SAHARA R50-TO-R25 PRODUCT CIRCUIT CHANGES REQUIRING FCC CLASS II PERMISSIVE FILING

Figure 1. ReFLEX 50 Power Management

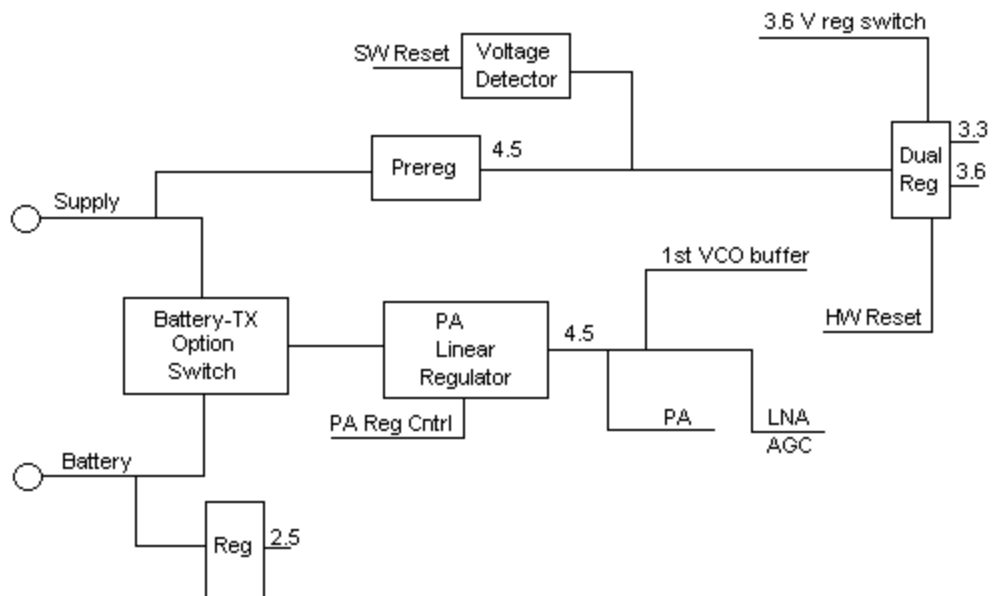
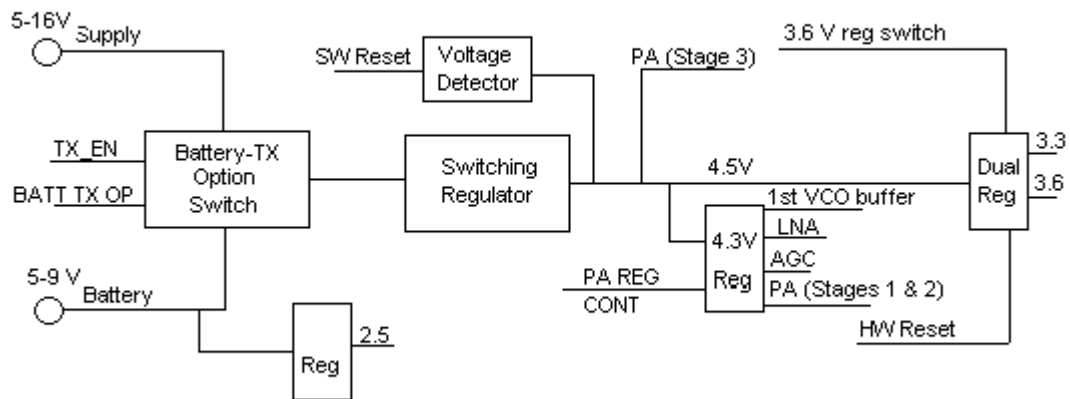
- Power management architecture for improved thermal operation and higher maximum operating voltage (see Figures 1 and 2). Transmit spurs can be observed at ± 500 kHz offsets from the carrier. These spurs are due to the AM-to-PM conversion of the switching regulator's voltage ripple present at the supply connections of the transmitter power amplifier U770. U770 is a 3-stage amplifier IC.

Details: Replaced 4.5 V linear regulators U230 and U240 with one (1) 4.5 V switching regulator (U240). A 4.3 V linear regulator (U230) was added to the output of U240 for cleaner supply to critical RF stages. Also includes changes to the regulators' application circuitry (pass transistors, bias resistors, capacitors, and inductors).

For the R50 product, all three stages of U770 were supplied DC current by the 4.5 V linear regulator U240. For the R25 product, the first two stages of U770 are supplied DC current by the 4.3 V linear regulator U230 to reduce spur generation, as these are DC supply-ripple sensitive stages. The third stage of U770 is supplied DC current by the 4.5 V switching regulator U240 since this stage is less sensitive to DC supply ripple and requires significantly more DC current than the first two stages of U770 (efficiency and thermal design requirement).

Figure 3. Spurious Emissions at Antenna Terminals: Carrier Frequency at ± 25 MHz
(HP 8594E Spectrum Analyzer)

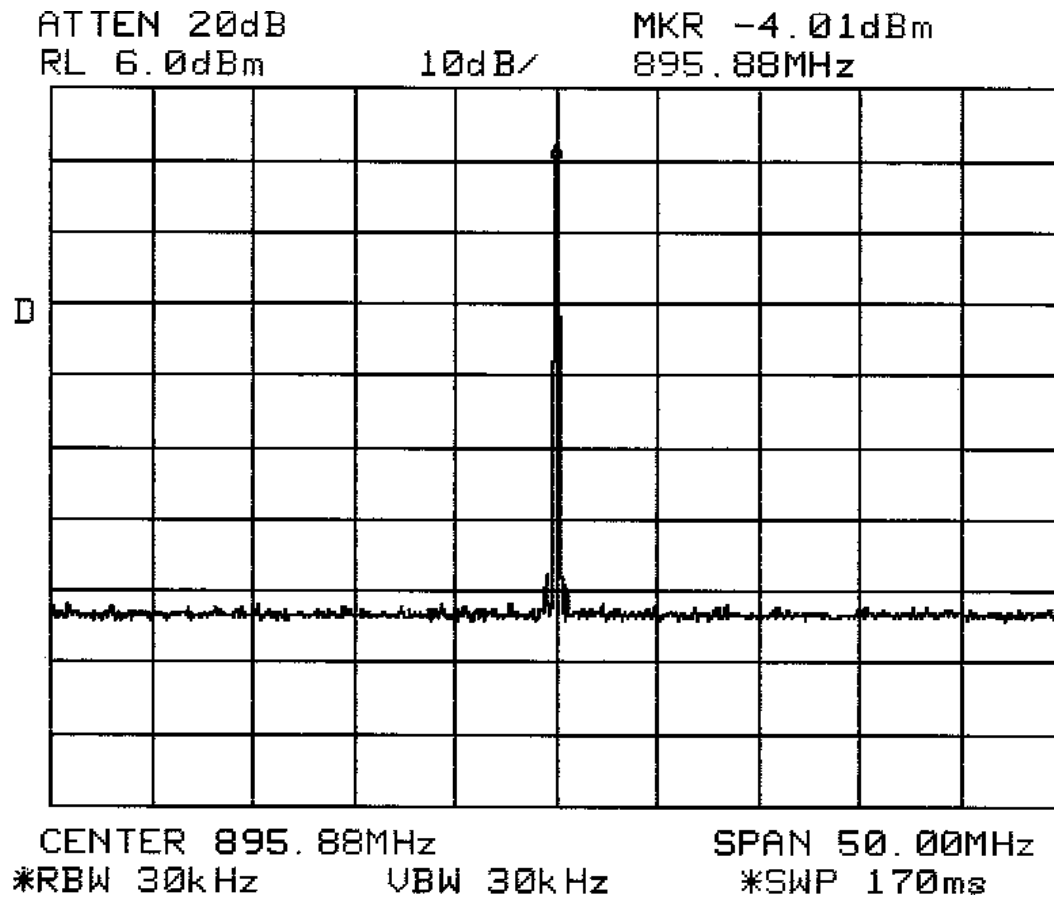
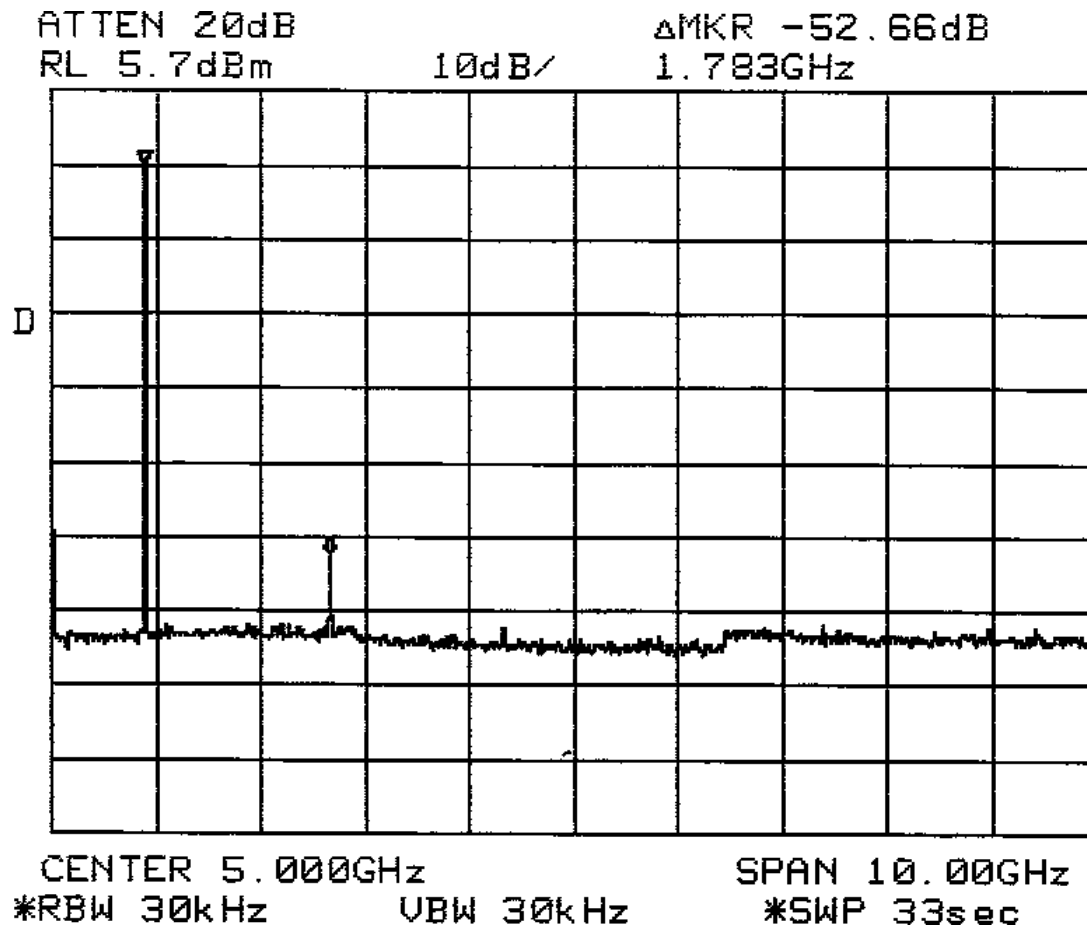
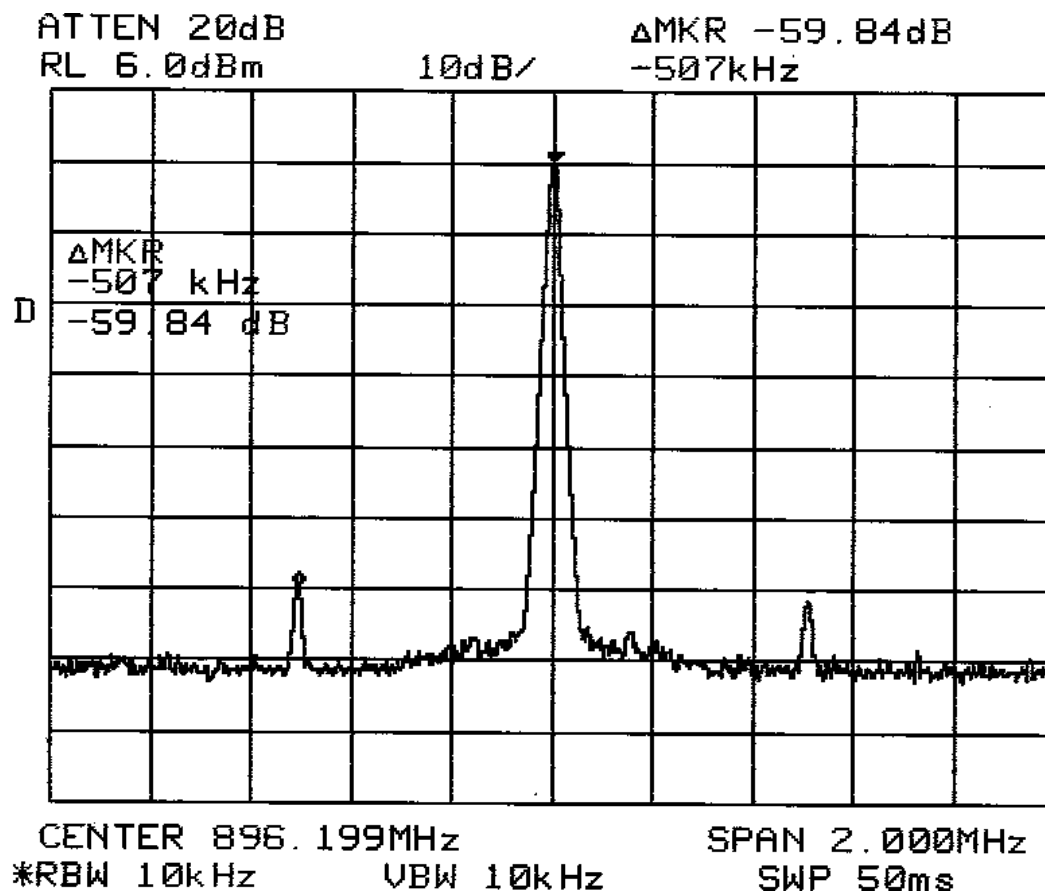
- Higher linearity PIN diodes used in antenna switch for improved receiver 1st image rejection. These diodes are also used for transmit function of the antenna switch. Since these diodes are higher linearity devices than used on the R50 product, improved transmitter harmonic performance is achieved.

Details: PIN diodes CR830 and CR831 changed to higher linearity devices. Also includes changes to parasitic tuning capacitors and inductors.

- Tuned antenna switch harmonic filter for improved transmitter 2nd harmonic rejection. This was not required; Re-tuned only as a transmitter performance enhancement.

Details: C836 capacitance was changed from 1.2 pF to 1.3 pF.

See Figures 3, 4, and 5 for transmitter spectral performance that was affected.
